Dwr Cymru Welsh Water Pre Planning Response Letter and Gravel Vehicle Access Track V-Ditch Layout Approved as Part of SAB Application Referenced 2024/0015/SFA

> Date: 05/03/2025 Our Ref: PPA0009236

Site Address: Land west of Rhydypandy Road, Rhydypandy Road, Morriston Swansea

Development: 2D- The Proposed Development comprises the construction and operation of a BESS of

Proposed Site Layout and Location Plans

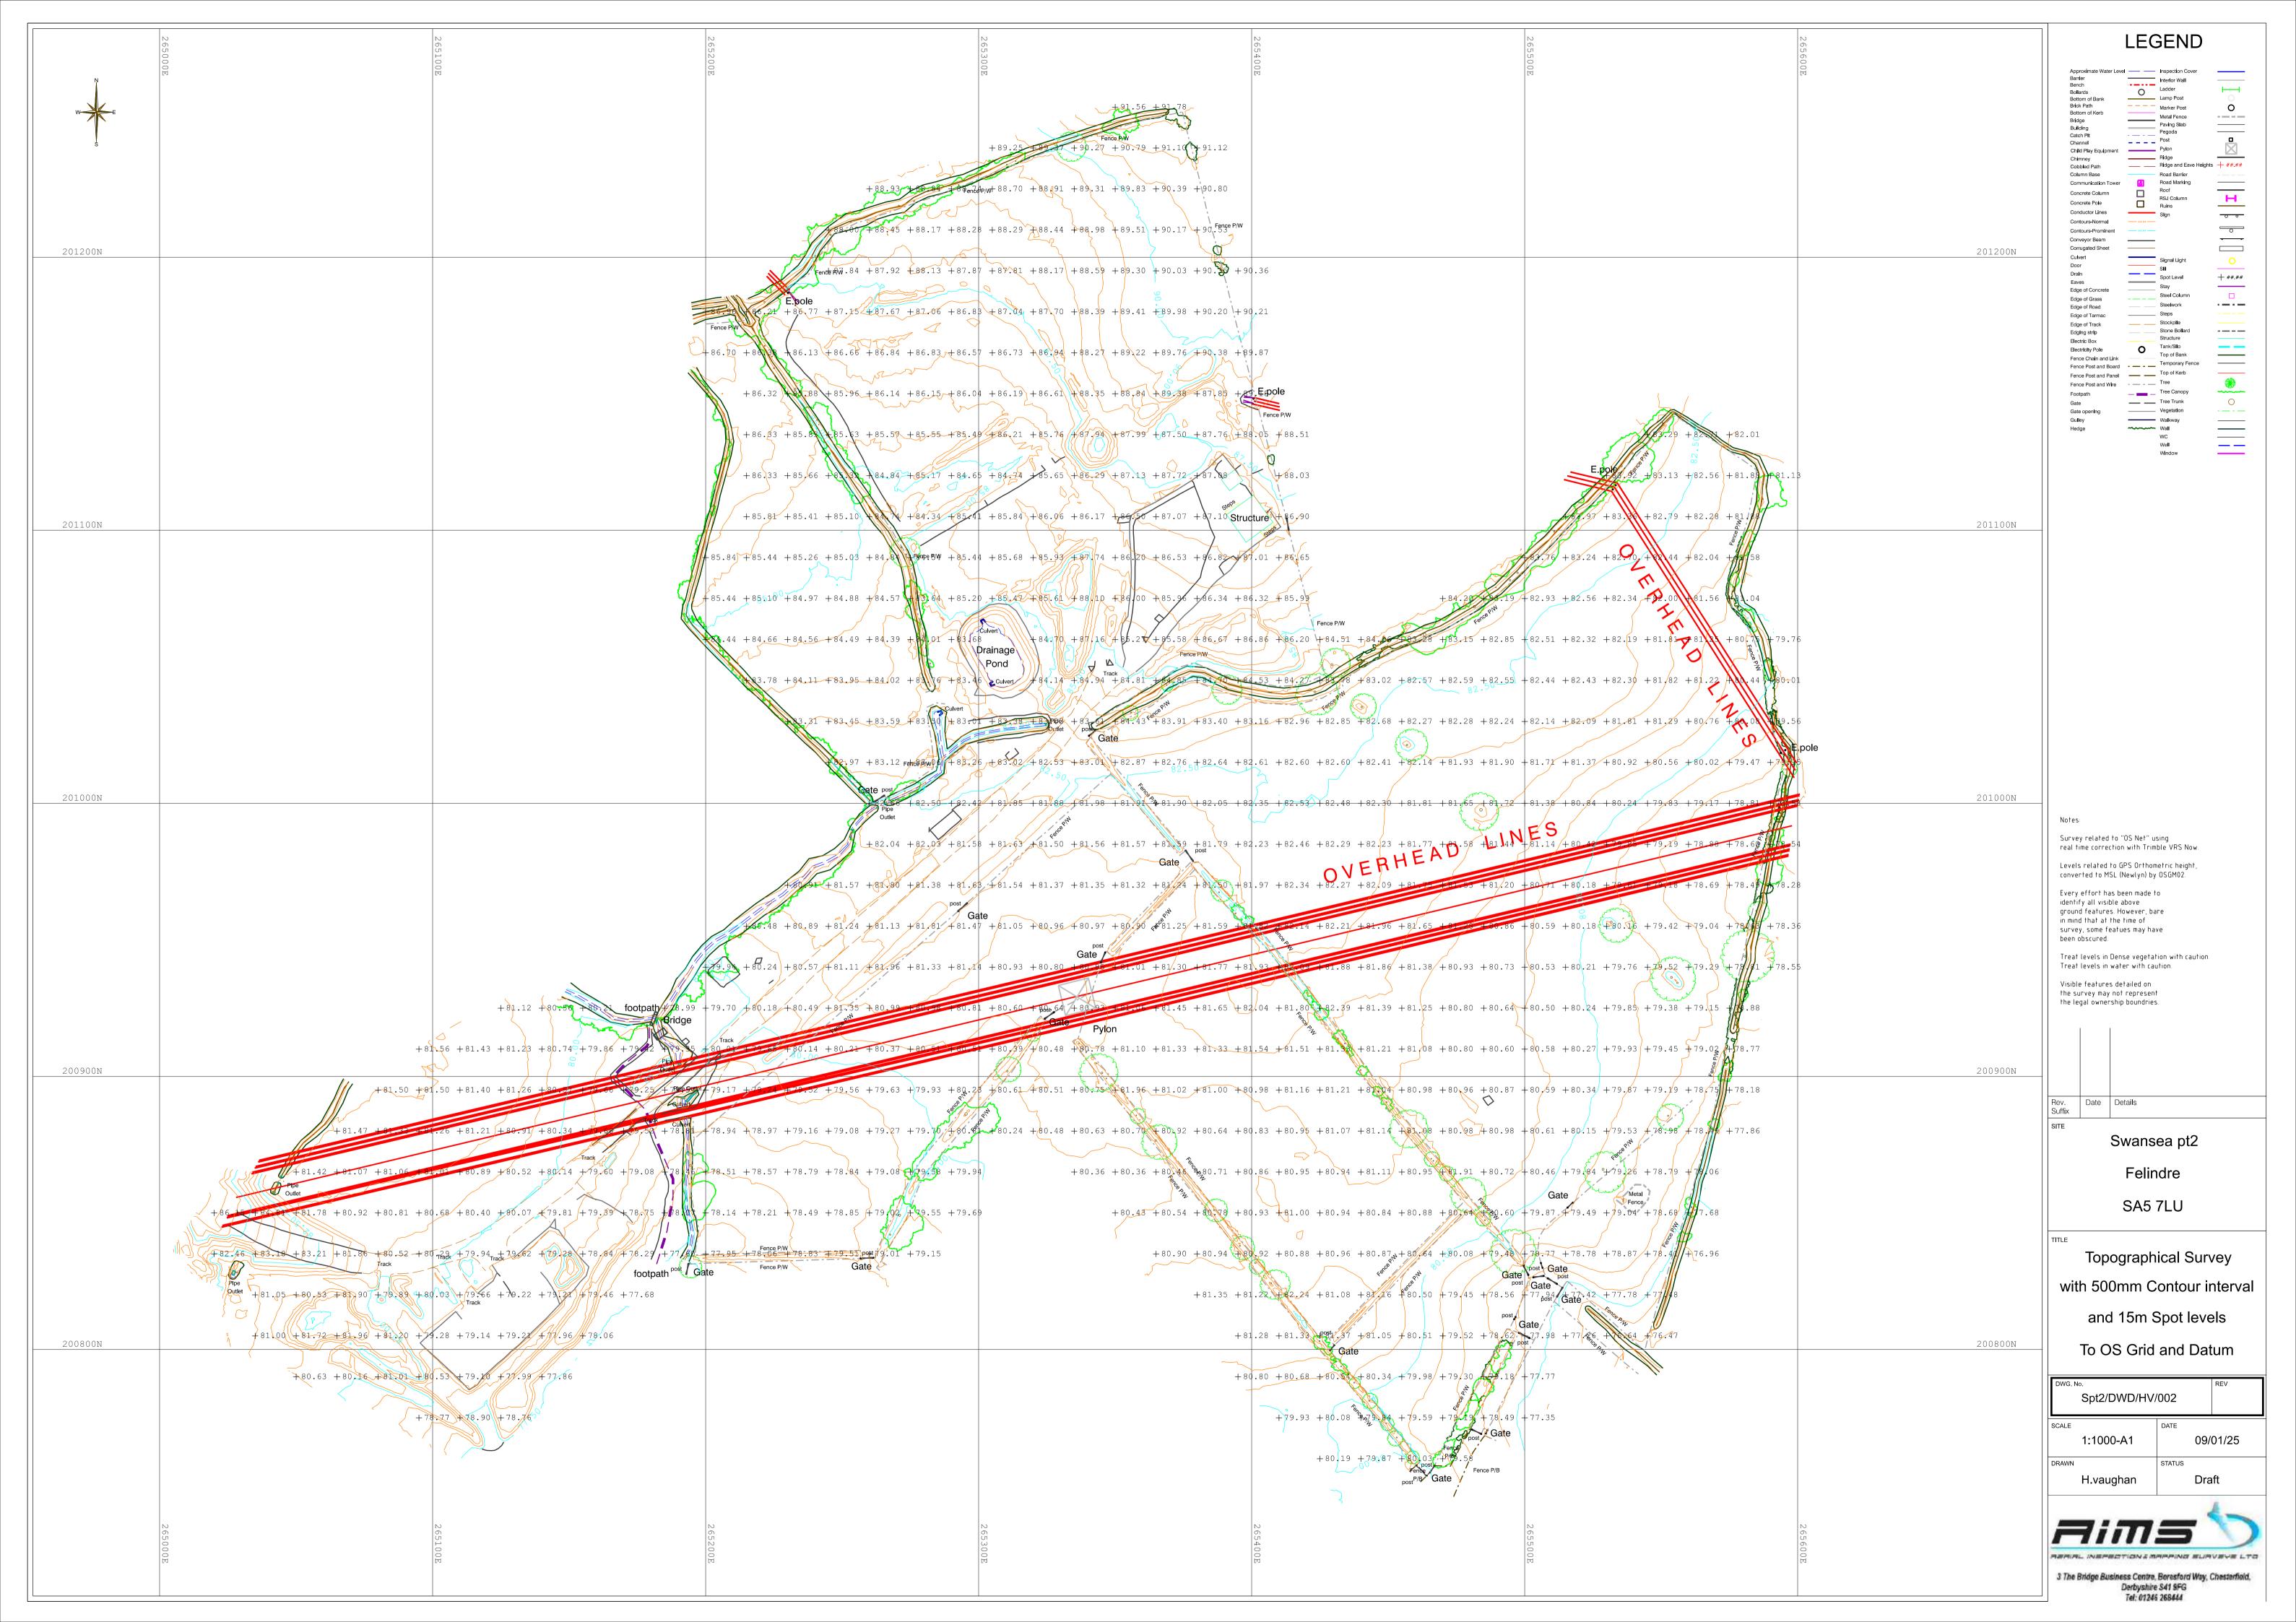
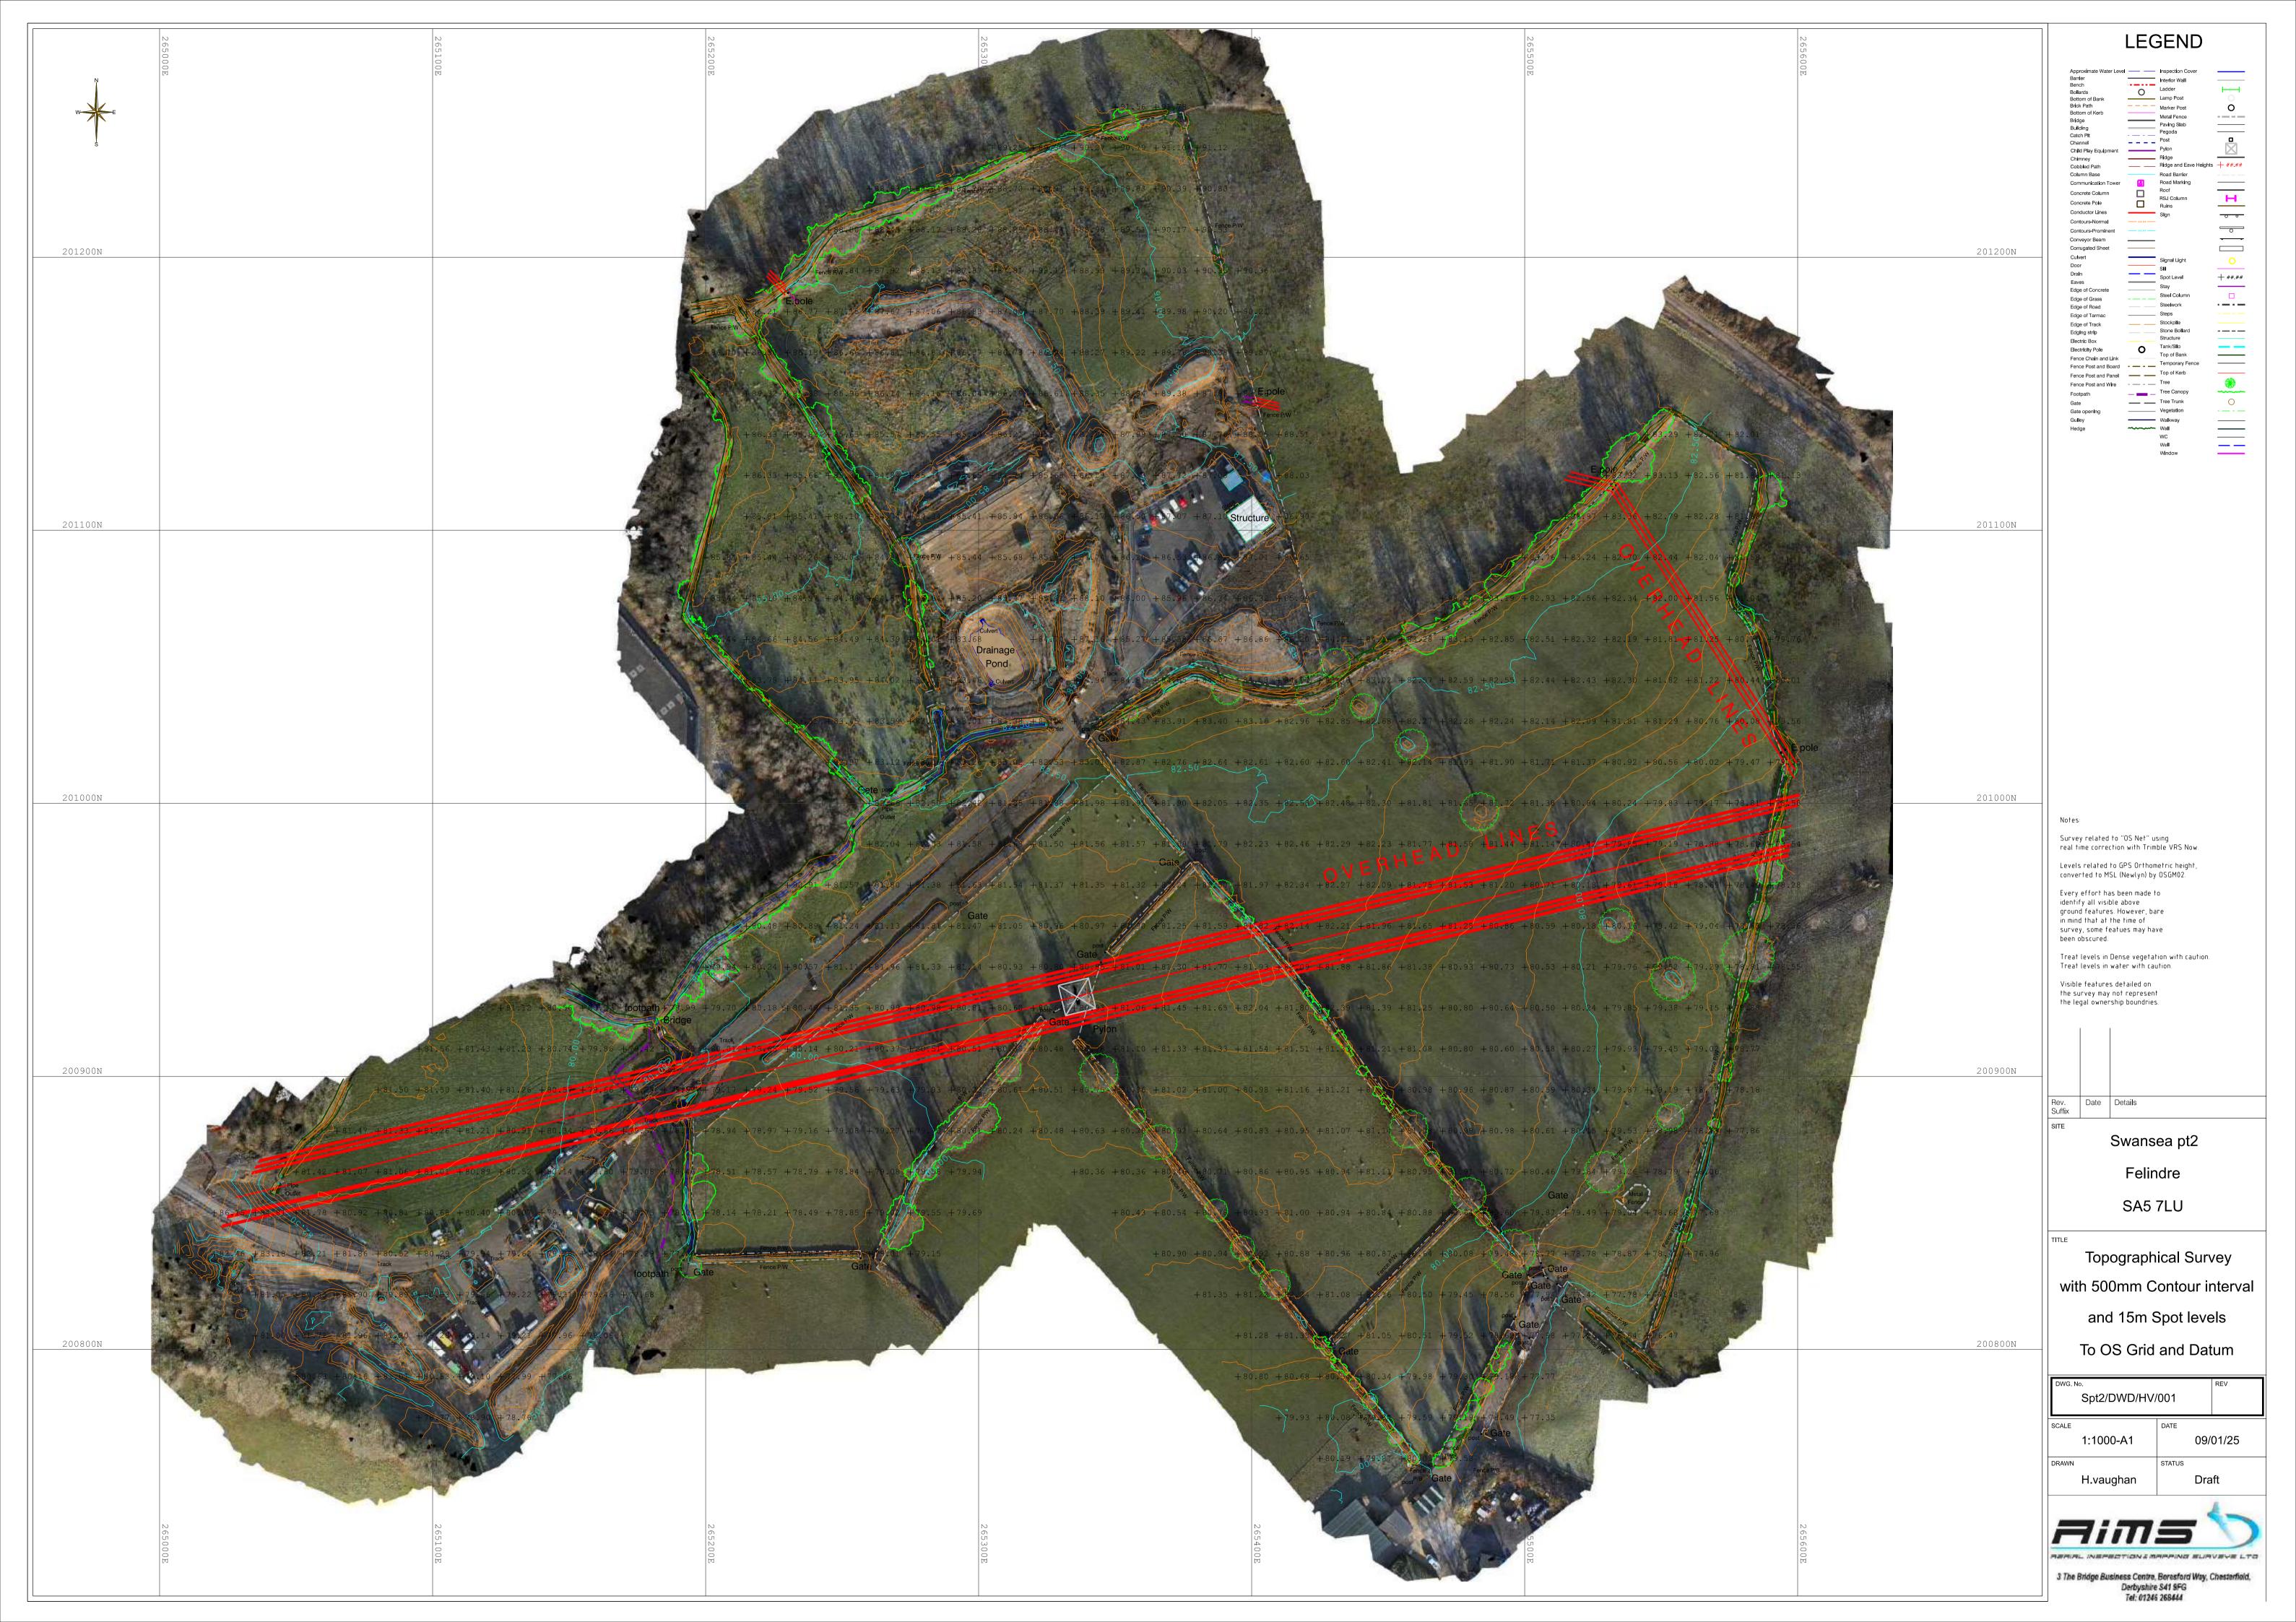
With respect to this latest pre-application consultation, and the accompanying 'Proposed Site Layout' (Rev. 06), we acknowledge that the development site boundary is sited at a distance sufficiently set back from the 66" trunk main. However, we acknowledge that the development will be accessed via a new access road as per the 'Site Layout Plan' (Drawing No. STA005-PL-02) which is crossed by 4" and 225mm trunk watermain, with their approximate positions being marked on the attached Statutory Public Watermains Record. Accordingly, it may be necessary for the developer to enter into an asset protection agreement in relation to these crossings and we would recommend the contact us to discuss further.
